MP10_160 Mod 6 White Rock Wind Farm (WRWF) - Further Information

This letter has been prepared by White Rock Wind Farm Pty Ltd (WRWFPL) in response to the Department's request for further information (RFI, email dated 21 November 2018), to address additional comments received from the Office of Environment and Heritage (OEH) and the Roads and Maritime Service (RMS).

1. OEH Request for Further Information (Letter dated 5 November 2018)

2. RMS Request for Further Information (Email dated 8 November 2018)

168.1 Km's: Wybong Road onto Kayuga Road at Muswellbrook.

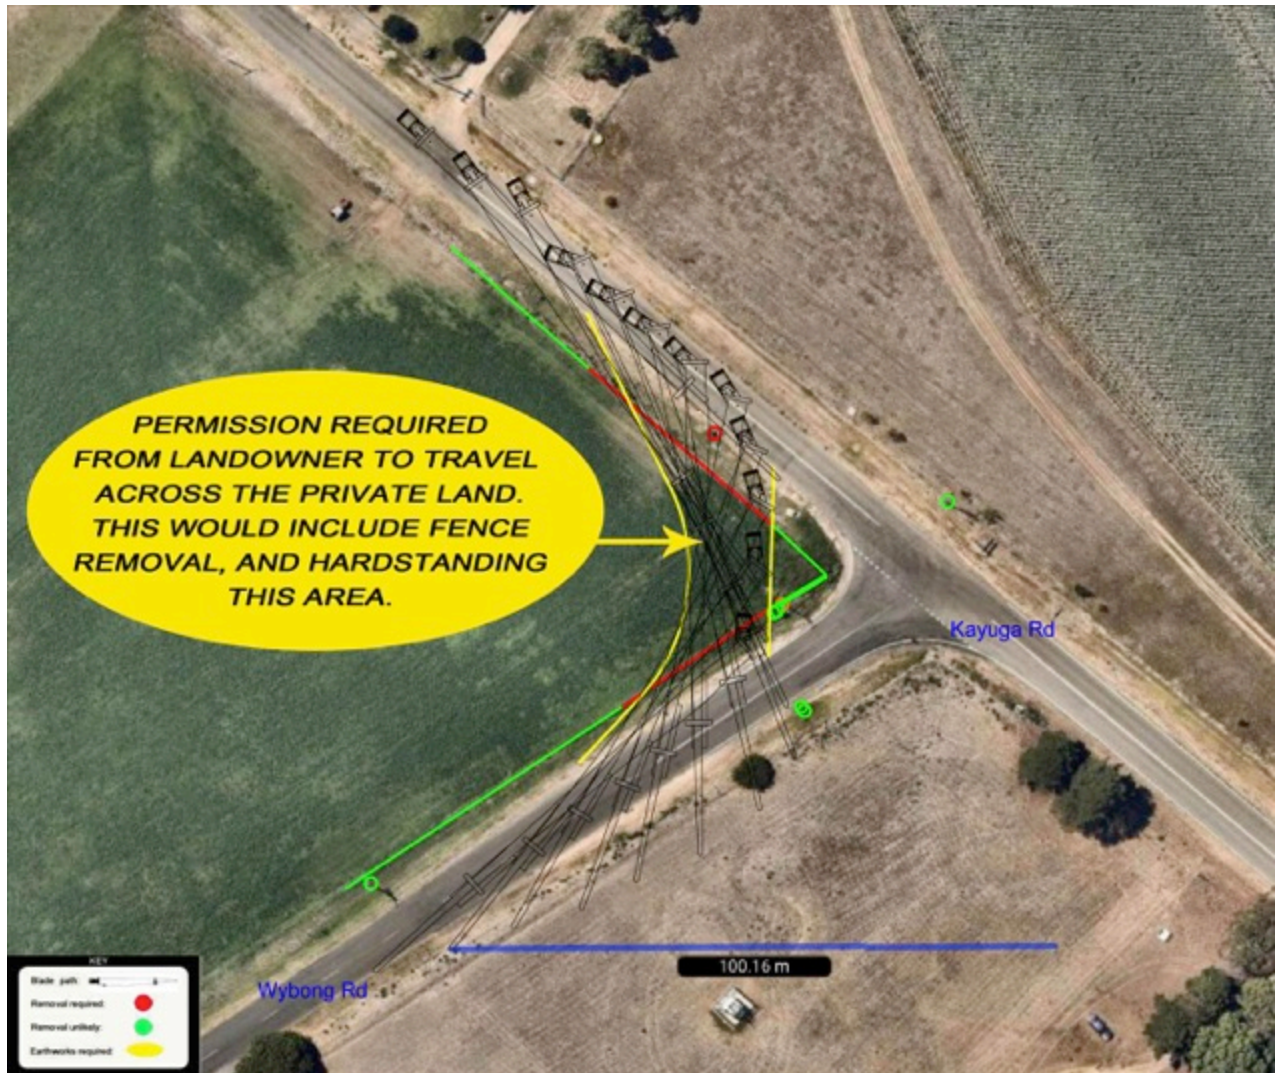
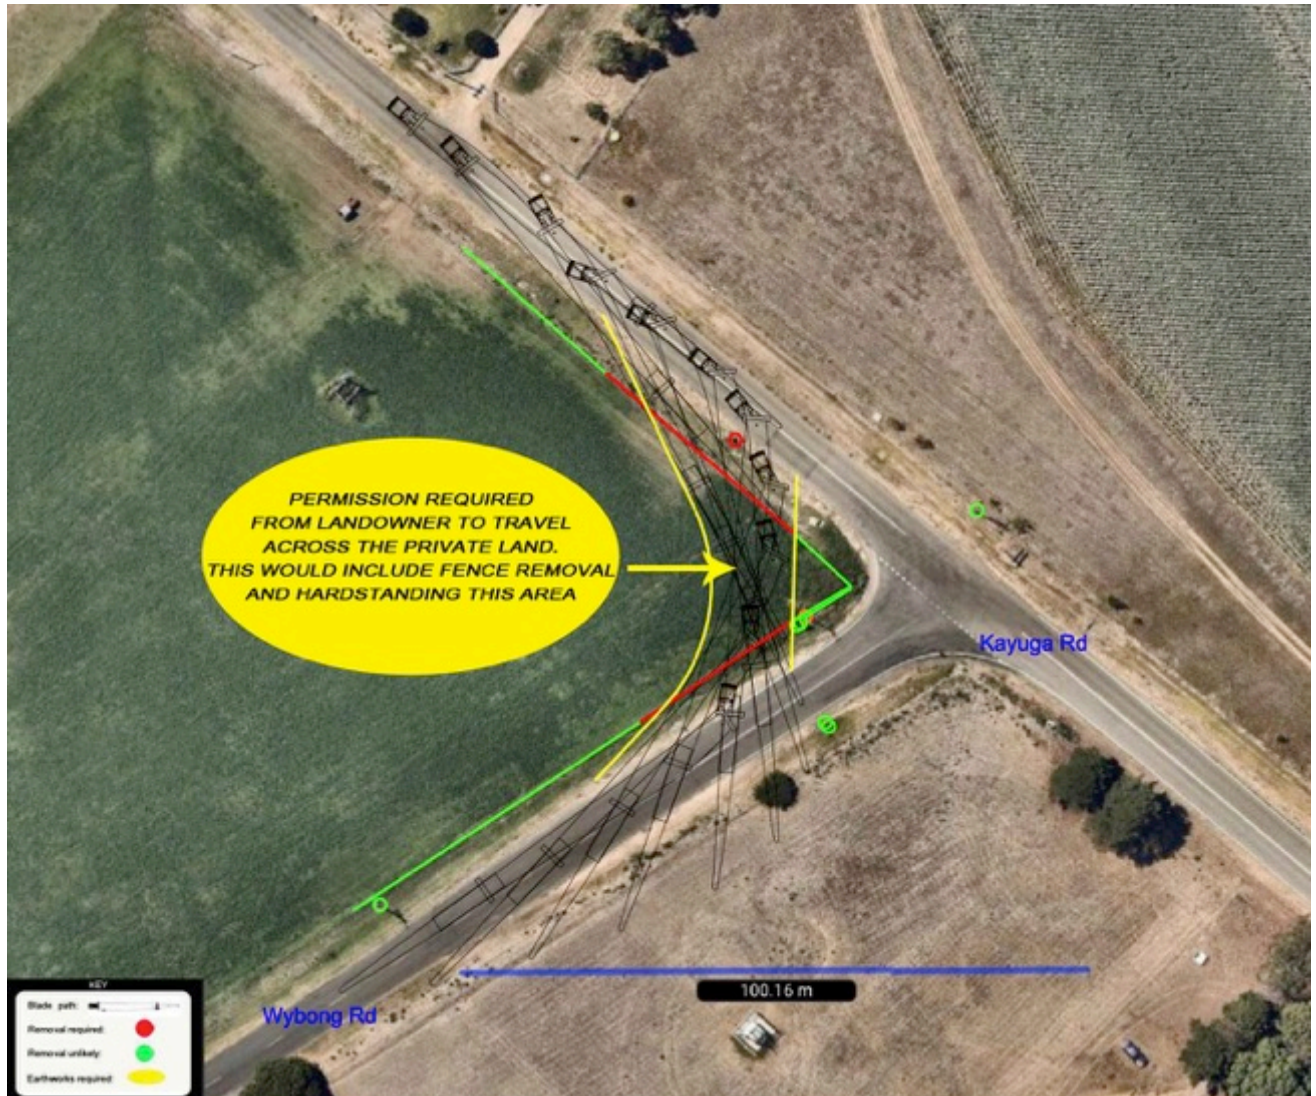
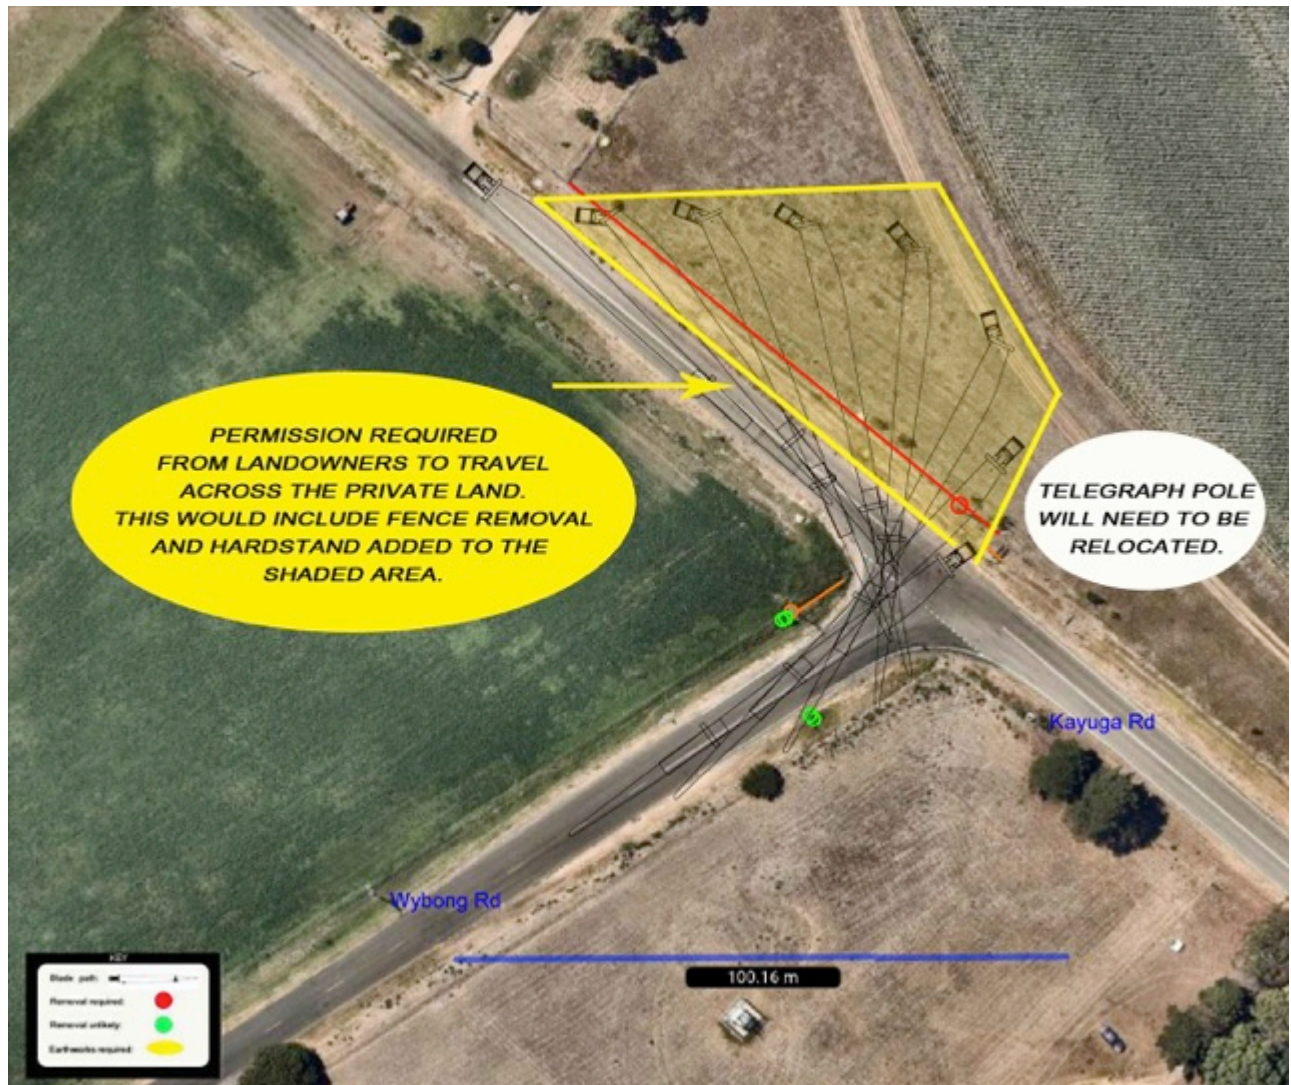
COMMENTS: Blades to cross from the incorrect side to the incorrect side. Some signs will be required from the landowner to travel over the private land. This will require removal and realigning the fence, and adding hardstand. Police and escorts to control local traffic either side of the intersection.

COMMENTS: Blades to cross from the incorrect side to the incorrect side. A telegraph pole will need to be relocated and some signs will need to be relocated or made removable. Permission will be required from the landowner to travel over the private land to the north of the intersection. This will require removal and realigning the fence, and adding hardstand. Police and escorts to control local traffic either side of the intersection.

ROAD MODIFICATIONS: Large amounts of work are required.

ROAD MODIFICATIONS: Large amounts of work are required.

ROAD MODIFICATIONS: Large amounts of work are required.

ROAD MODIFICATIONS: Large amounts of work are required.

174.0 Km's: Ivermein Street onto Dartbrook access Road at Muswellbrook.

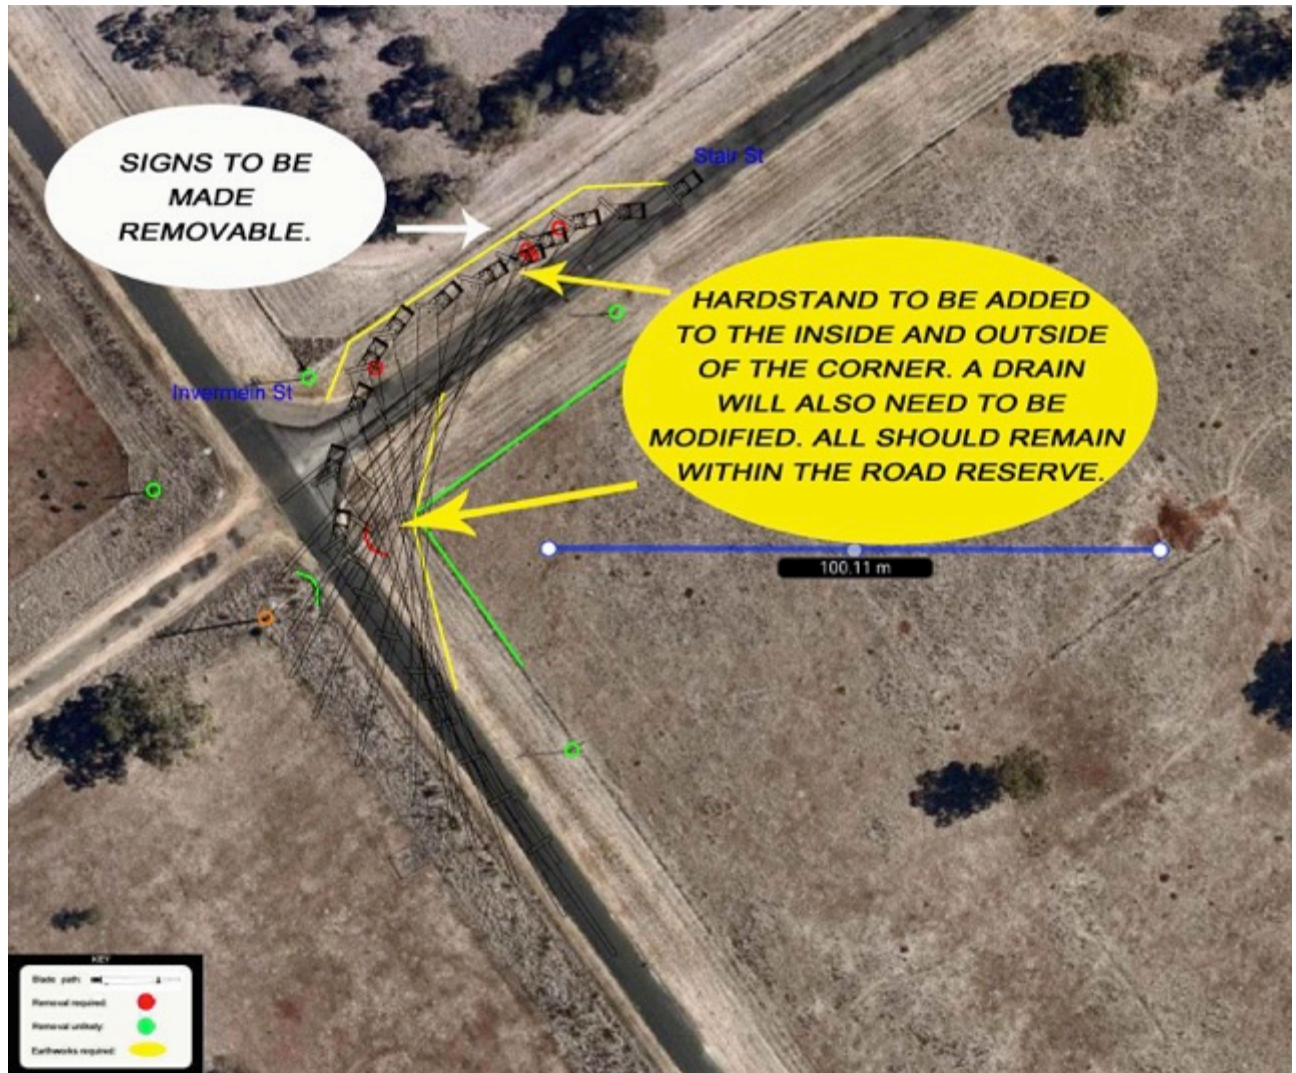
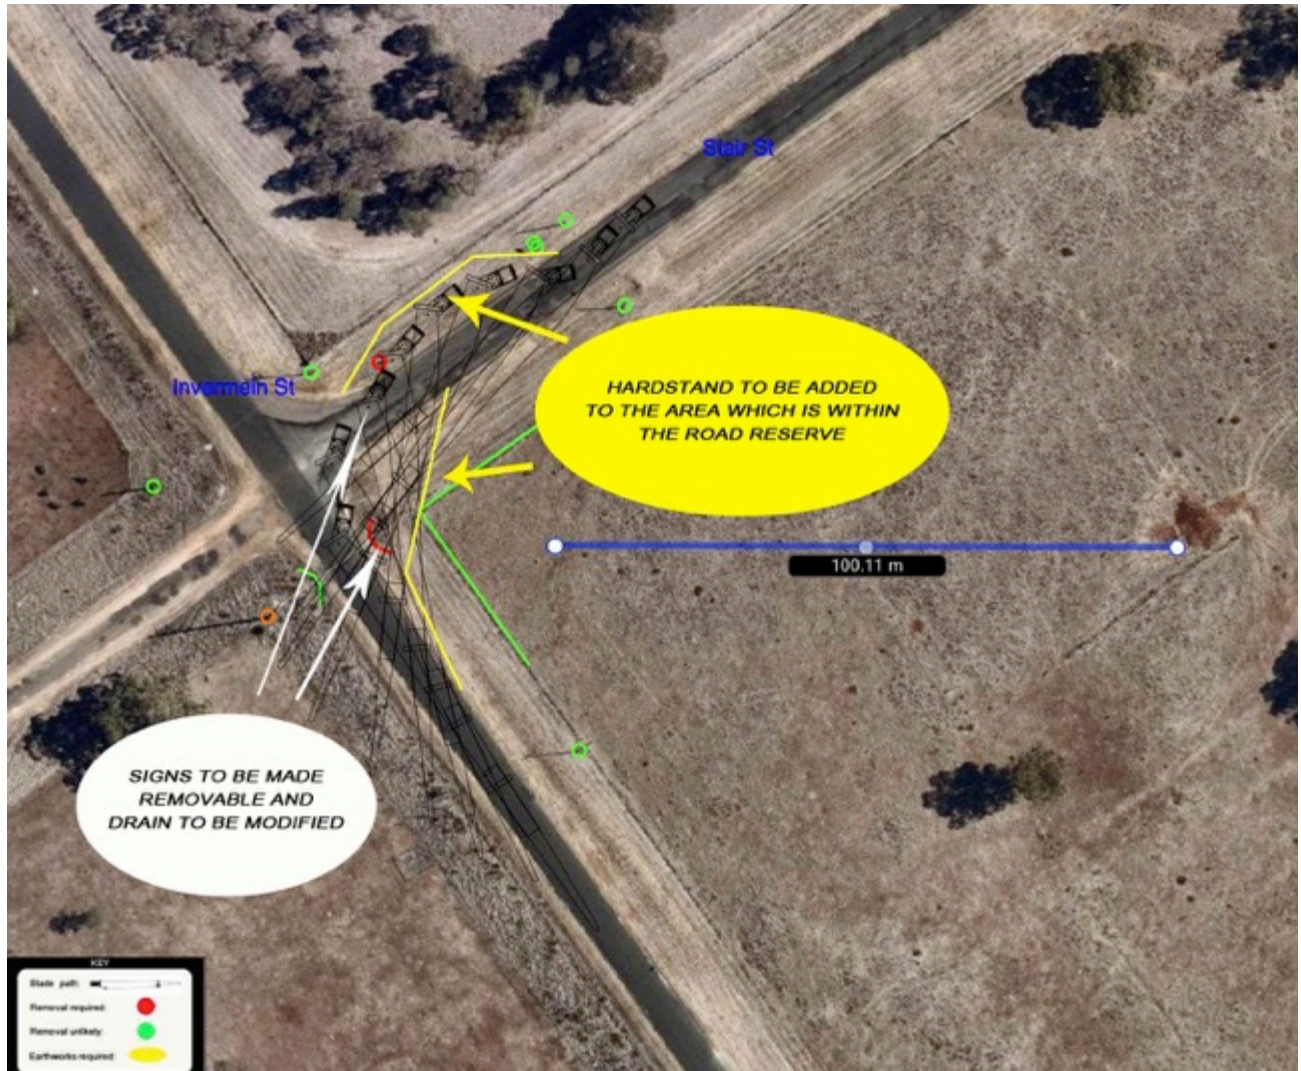
COMMENTS: Blades to cross from the correct side to the correct side. Some signs will need to be made removable and some hardstand added to the inside and outside of the corner. Additionally a pipe will need to be extended on the inside of the corner. Police and escorts to control local traffic either side of the intersection.

COMMENTS: Blades to cross from the correct side to the correct side. Some signs will need to be made removable and some hardstand added to the inside and outside of the corner. Additionally a pipe will need to be extended on the inside of the corner. Police and escorts to control local traffic either side of the intersection.

ROAD MODIFICATIONS: Moderate amounts of work are required.

ROAD MODIFICATIONS: Moderate amounts of work are required.

323.0 Km's: Murray Street onto New England Highway at Tamworth.

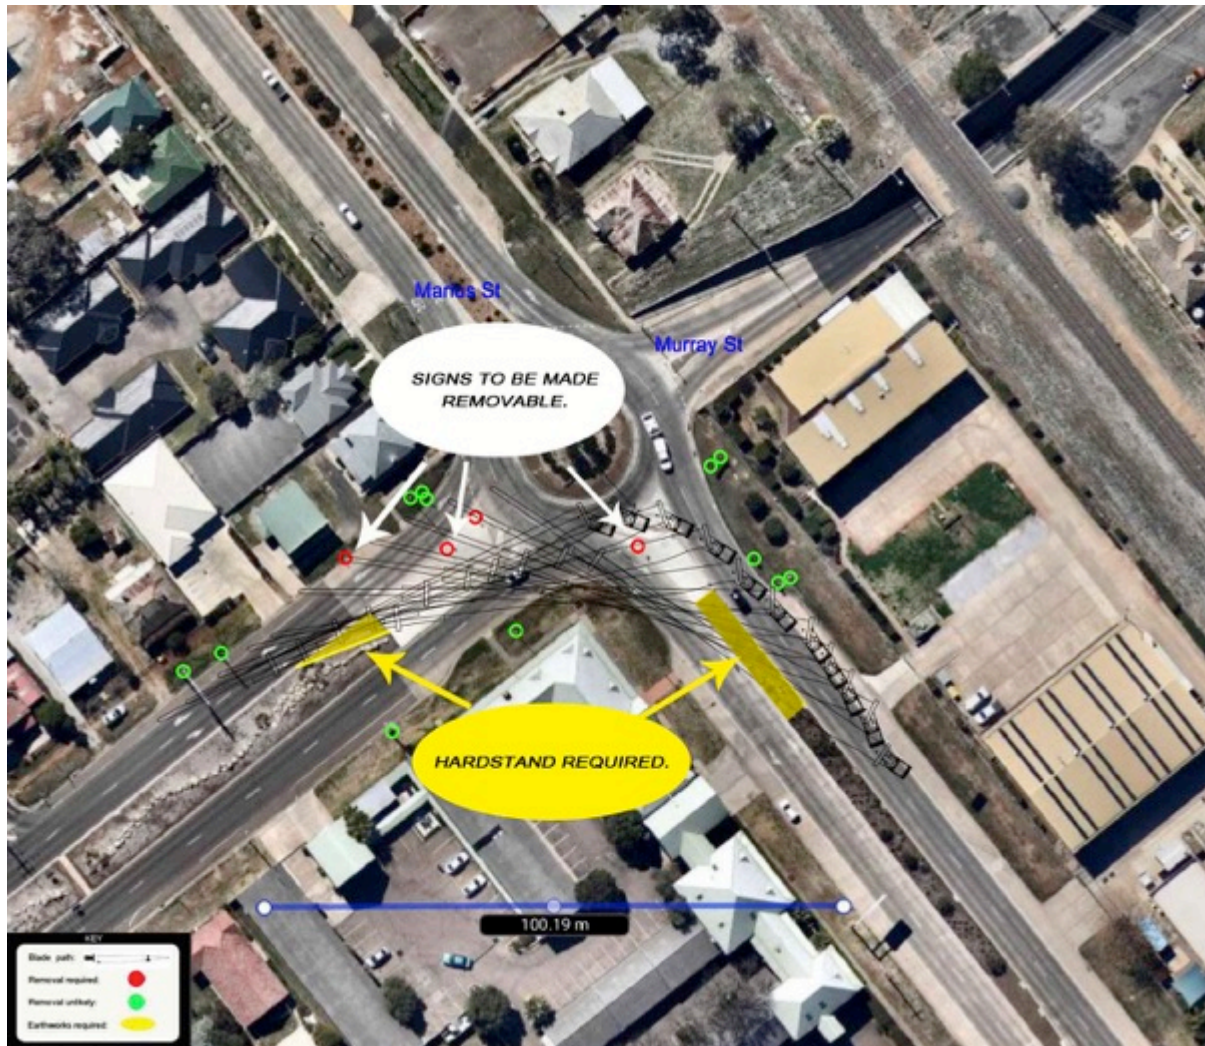
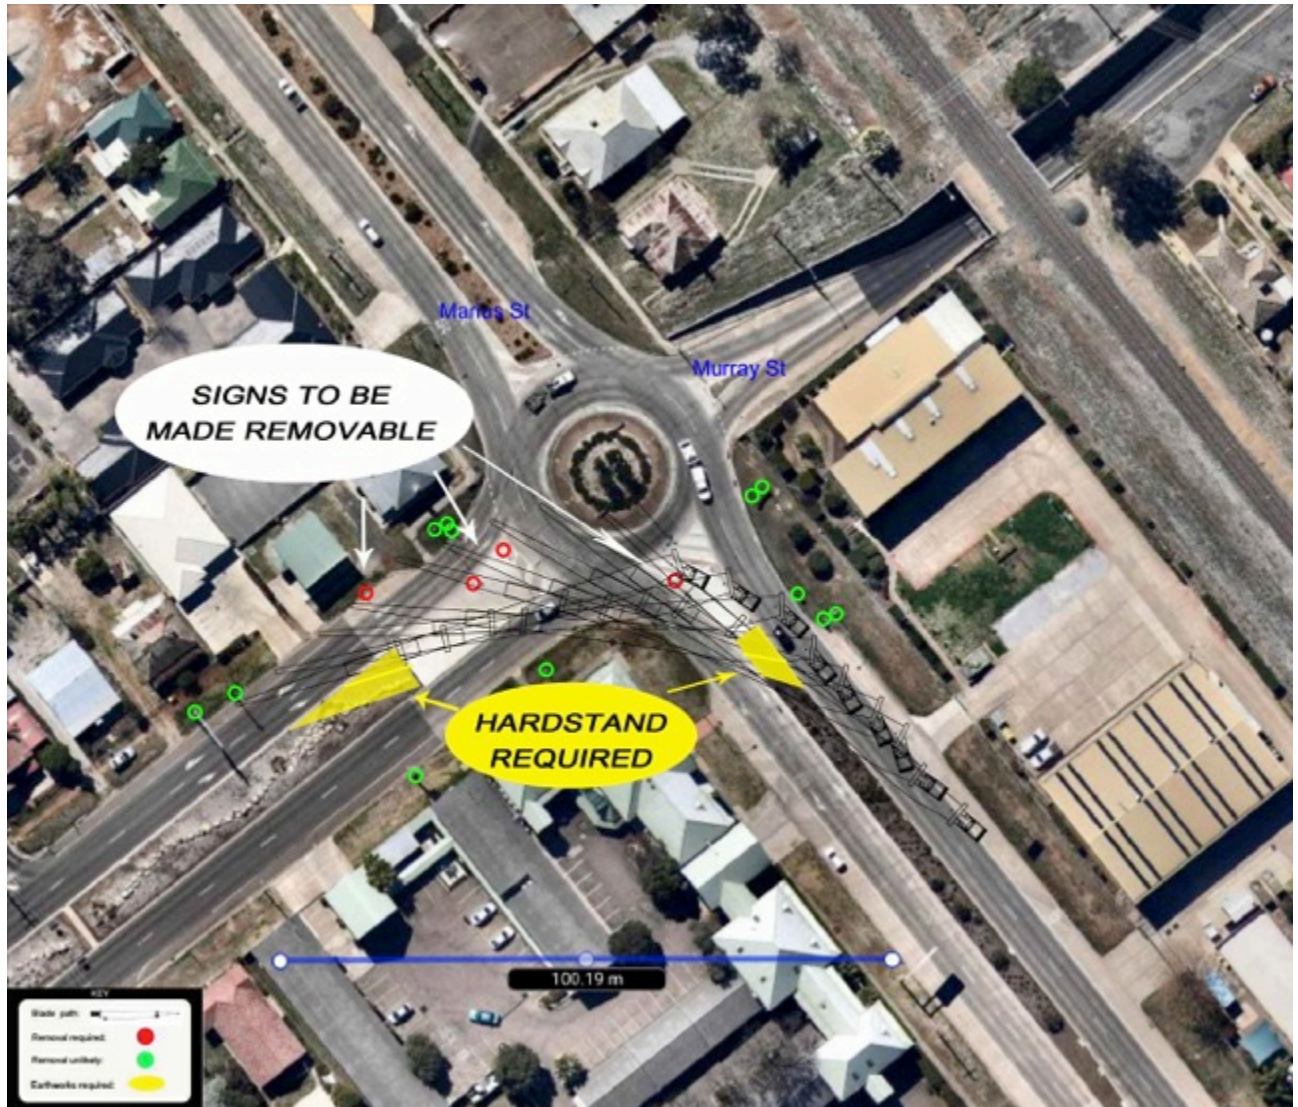
COMMENTS: This intersection will require the 2 median strips to be hardstand, and several signs made removable.

ROAD MODIFICATIONS: Large amounts of work are required.
